Feedback in response to the public consultation on the Federal Development Plan for the Belgian transmission system (110kV to 380kV) over the period 2024-2034

In this reaction, Belgian Offshore Platform responds to the public consultation on the draft Federal Development Plan for the Belgian transmission system (110kV to 380kV) over the period 2024-2034 – “On the road to a carbon neutral society by 2050” and the accompanying environmental impact report as launched by Elia on 2nd of November 2022.

Figure 1 – Assumptions on installed offshore wind capacity (FDP - §2.1.6 - page 119)

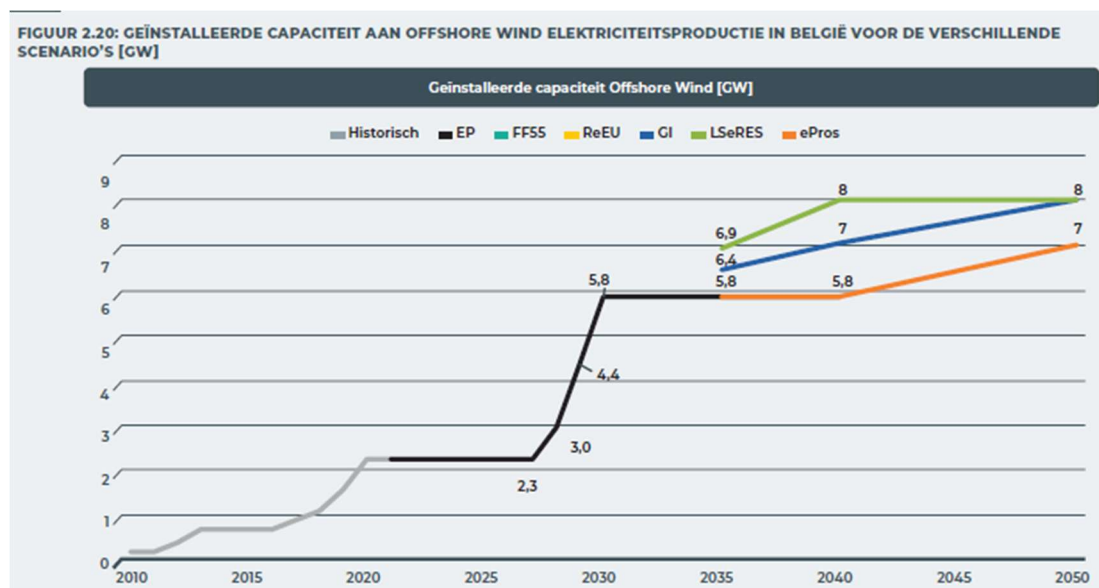
BOP regrets that Elia takes the assumption that 8GW of offshore wind in Belgium is, in the most optimal scenario, only achieved by 2040. Although the federal government did not yet decide on a target date for the 8GW ambition, this assumption clearly lacks ambition by accounting for 18 years of development time to add 2.2GW of offshore wind. Elia only takes 'repowering' of the existing wind parks into account its assumptions.

Elia makes the assumption that additional growth in offshore wind in Belgium, beyond the 5.8GW already planned, will only occur as of 2035; conveniently outside of the scope of this FDP. BOP is of the opinion that this additional growth can, and should, occur sooner, and that Elia must thus, already now, plan for the necessary grid investments. If not, we will see that for the third time in history, the grid development will be the delaying factor in offshore developments, instead of the enabling factor.

Figure 3 – Energy hubs as cornerstones of RES integration (Elia TF MOG2 – 10 Oct 2022)

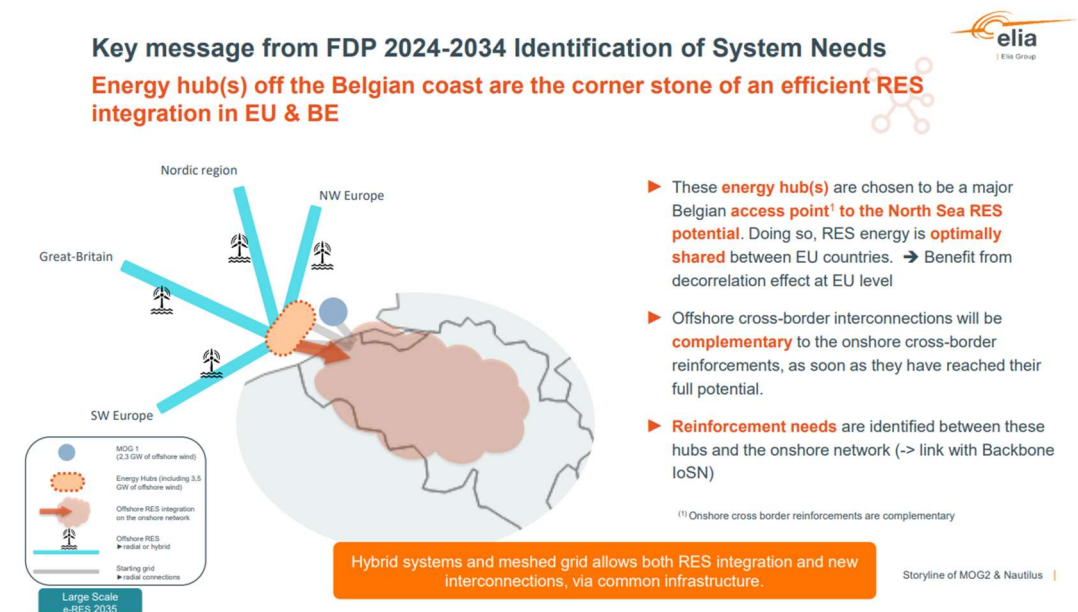
BOP can support the concept of an energy hub, as, when properly designed, it can create redundancy in transmission capacity from the hub to shore. However, here again BOP sees a strong mismatch between the generic statements and future vision of Elia, and the actual grid projects elaborated upon in the FDP.

In this Elia vision, the offshore energy (from the PE zone and from abroad) will be concentrated on the PE island. At the moment, 4.9GW of energy projects are already foreseen to be concentrated on the island (1.4GW Nautilus + 3.5GW PEZ offshore wind). The connection capacity from the island to the shore, however, is only foreseen to have a capacity of 3.5GW, i.e. an under-dimensioning of almost 30%. At the same time, Elia proposed to concentrate even more energy projects (production capacity or interconnectors) on the island, without any concrete proposal to expand the connection capacity to shore. Also, no alternatives are foreseen, even not analysed, such as batteries on or near the island, electrolysis on the island and a pipeline instead of power connection to shore. Such solutions would ensure no renewable electrons are lost as a consequence of curtailment and can be an economically viable alternative on the short terms, if physical constraints prevent the immediate build out of more grid connection capacity.

The implementation of this vision in the draft FDP is lagging the offshore ambition and has not quantitatively optimized the capacity from the PE island towards inland Belgium.

Figure 4 - Overall optimization results of the KARI study

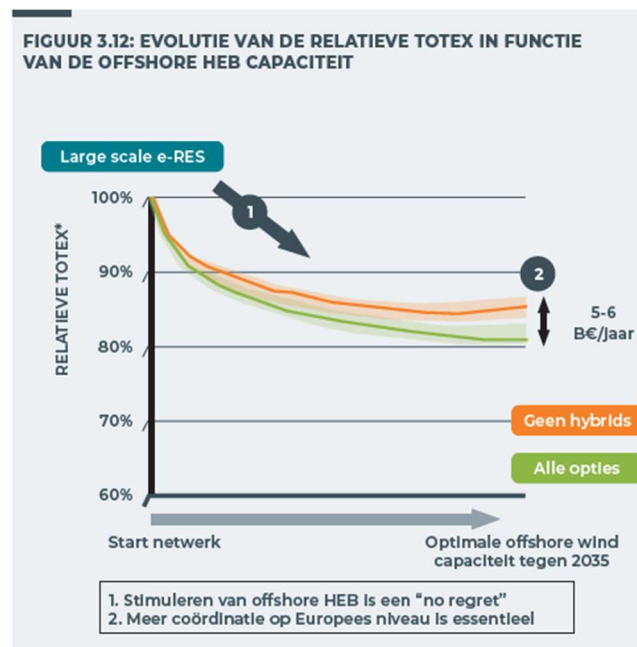
Figure 4 shows that stimulating offshore energy is a “no regret”: regardless of grid optimization offshore wind developments result in tens of billions of costs reductions, due to a.o. fuel savings and societal benefits related to CO₂ emission reductions. **The gains in optimizing the grid via hybrid projects is much smaller than the gains of the offshore wind developments themselves. The priority should be at realizing and connecting the wind developments as fast as possible, hence justifying a proactive approach in grid investments.**

Moreover, the results presented from KARI study do not answer some crucial questions which are relevant to this Federal Development Plan, i.e.:

BOP asks more transparency on the assumptions and results coming out of the KARI-study specifically related to integrating offshore renewable energy towards Belgium. In particular, the optimal grid design resulting from this study is to be published.

Figure 5 – Optimization of the grid with onshore reinforcements

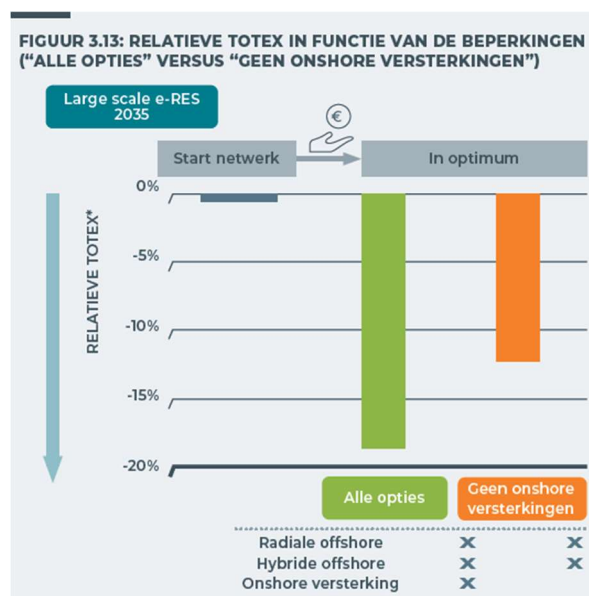
The same questions are to be asked related to the need for reinforcing the onshore grid. Only overall optimal results are presented (cf. Figure 5) and no details are shared related to specific effects for the Belgian onshore grid.

From the results presented from the KARI study one cannot conclude that the hybrid grid design proposed by Elia for MOG 2 and Nautilus between the North Sea and Belgium is the optimal grid design (by 2035) from a societal perspective. It only partially shows the potential of hybrid projects in the development of a larger offshore grid.

Figure 6 – Loads on the internal backbone (FitFor55 2030 scenario)

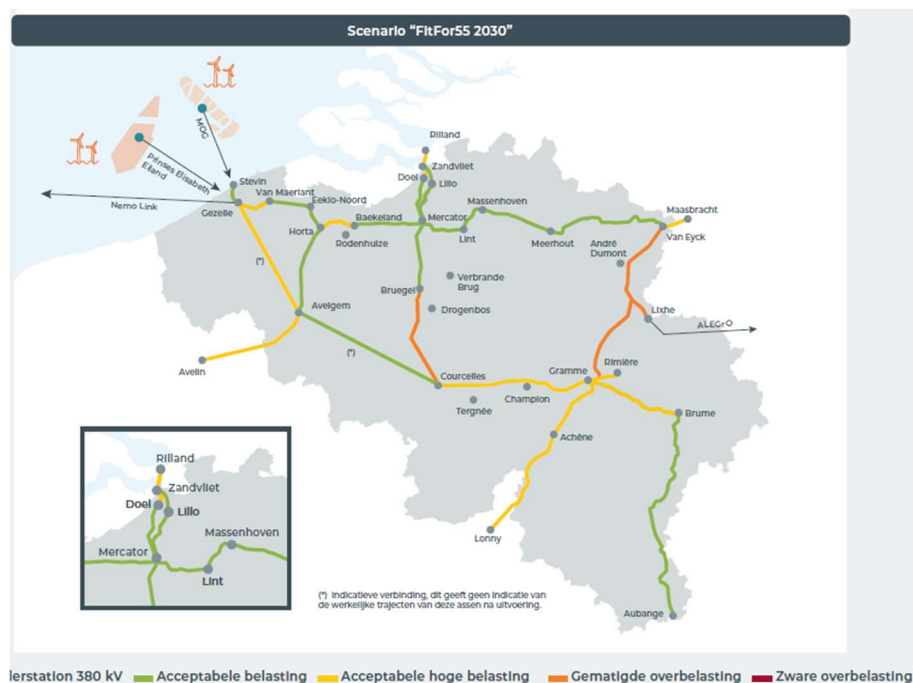
In the reference grid of 2030, high loads are observed in West-Flanders, without the inclusion of Nautilus (cf. Figure 6). The Nautilus interconnector is planned for commissioning in 2030. Why is this cable excluded and what would be the effect on the internal backbone? Is the integration of the offshore wind projects in the PEZ secured, without curtailments/redispach, for the first years following 2030, prior to the finalization of the planned reinforcements on the internal backbone?

Furthermore, the grid connection capacity to shore from Nautilus and MOG 2 is constrained to 3.5GW in the offshore grid design proposed by Elia. What would be the loads on the internal backbone if the grid capacity to shore is increased to allow for the import of the full 4.9GW from the PEZ and the Nautilus interconnector into the Belgian onshore grid?

The analysis clearly confirms the need for further reinforcement of the internal backbone to be able to integrate the renewable energy from the North Sea.

Figure 7 - Loads on the internal backbone (Global Import 2035 scenario)

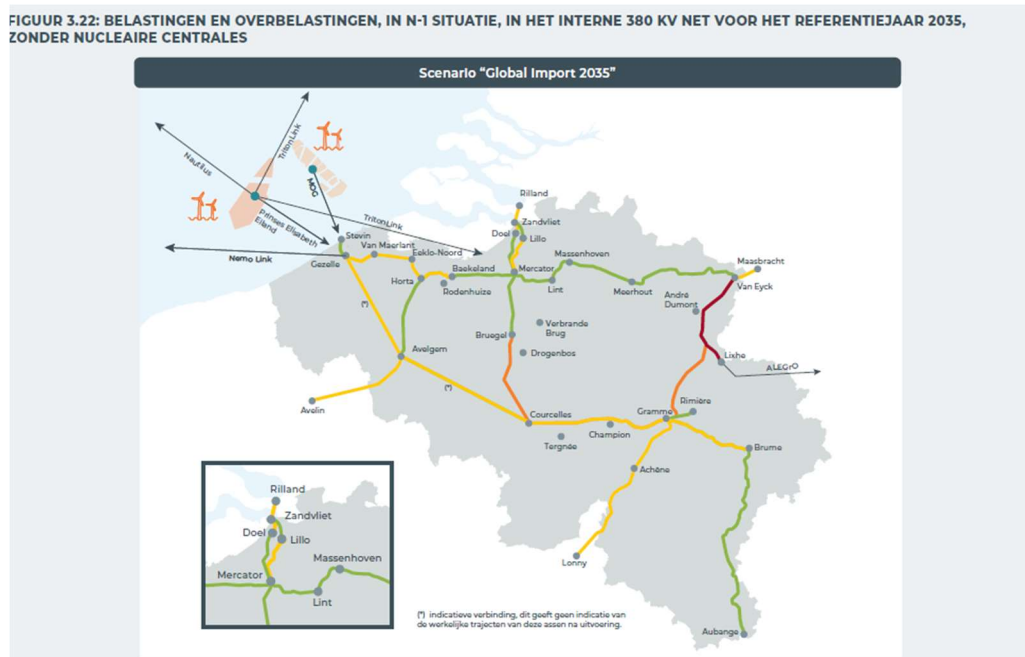
The analysis, based on a rather limited ambition in offshore wind developments by 2035 (5.8GW + 600MW), shows a clear need for further onshore grid reinforcements (after realization of Ventilus and Boucle du Hainaut) to allow integrating both offshore and onshore wind developments. **The reinforcements are required regardless of nuclear extension discussions and are even more pressing with a higher offshore wind ambition of 8GW prior to 2035.**

Figure 8 – High-level evolution of the 380kV grid in Belgium

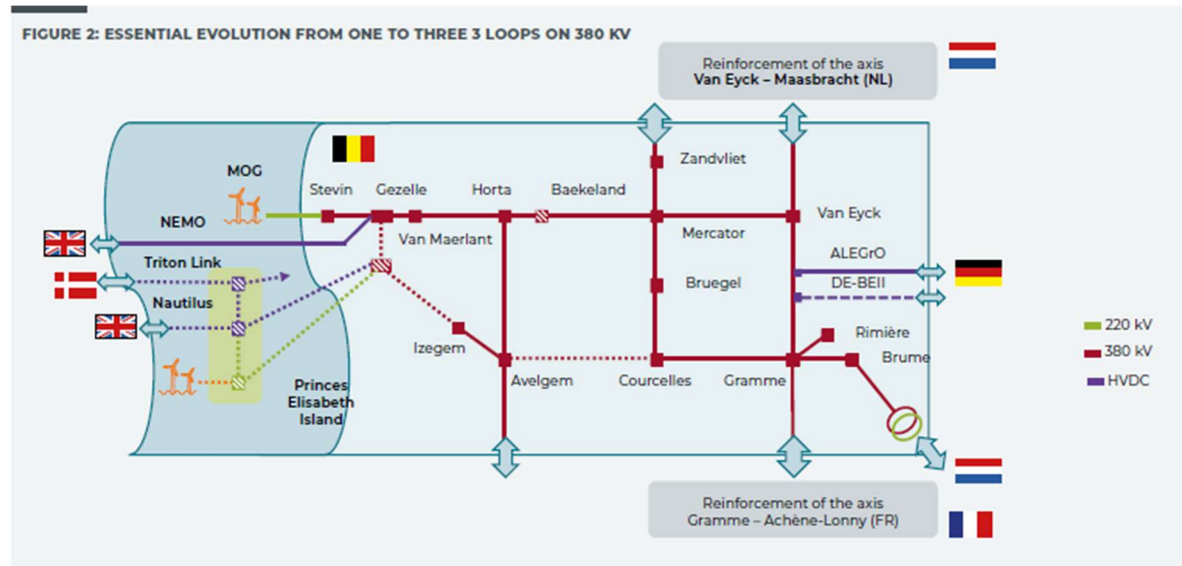
BOP supports the fast reinforcement of the 380kV backbone by closing the loops via the Ventilus and Boucle-du-Hainaut projects, but regrets that Elia does not take a proactive approach to implement its vision of accelerating the integration of offshore renewables from the North Sea.

Additional onshore reinforcements, on top of Ventilus, Boucle du Hainaut and TritonLink are required to host the future offshore developments. The needs and benefits are clearly identified, but not translated into concrete projects. Without these additional projects, once again, the grid developments will hamper the speed of the energy transition, the consolidation of Belgium's pioneering position in the offshore wind sector and the export possibilities of this valuable expertise abroad.
